## **ADDENDUM #3**

**May 4, 2012**

Re: Harrisburg Area Community College  
Gettysburg Campus Parking Lot Expansion  
Solicitation #RFB12-14

**GRADING AND UTILITIES PLAN**  
 FOR  
**PARKING LOT EXPANSION**  
 FOR  
**HACC, CENTRAL PENNSYLVANIA'S COMMUNITY COLLEGE**  
 CUMBERLAND TOWNSHIP, ADAMS COUNTY, PENNSYLVANIA

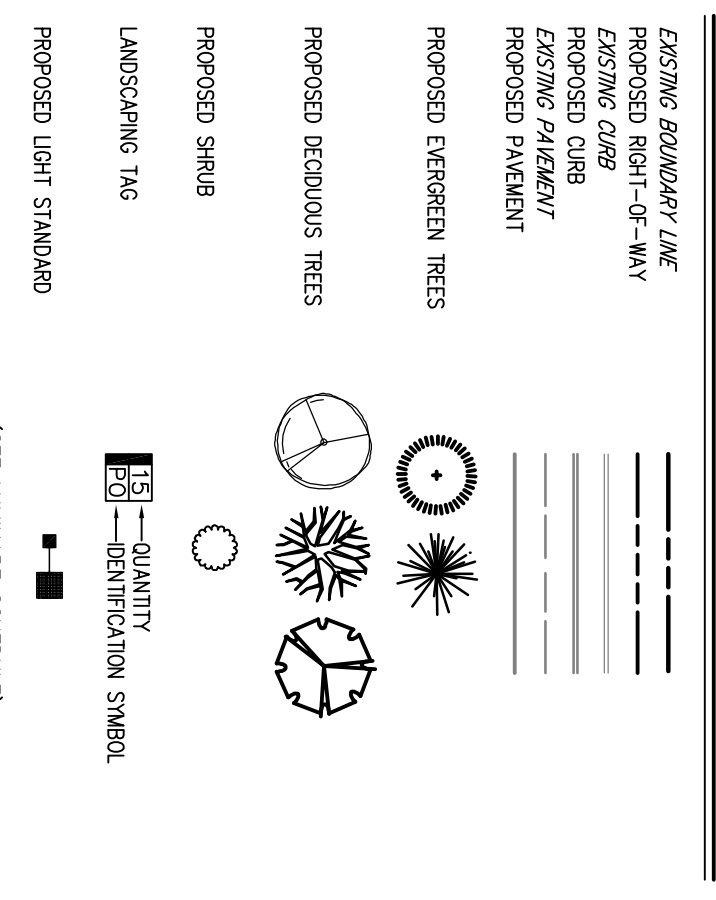
NO.	DATE	REVISION
3	05/03/12	PER ADDENDUM #03
1	04/20/12	PER ADDENDUM #01
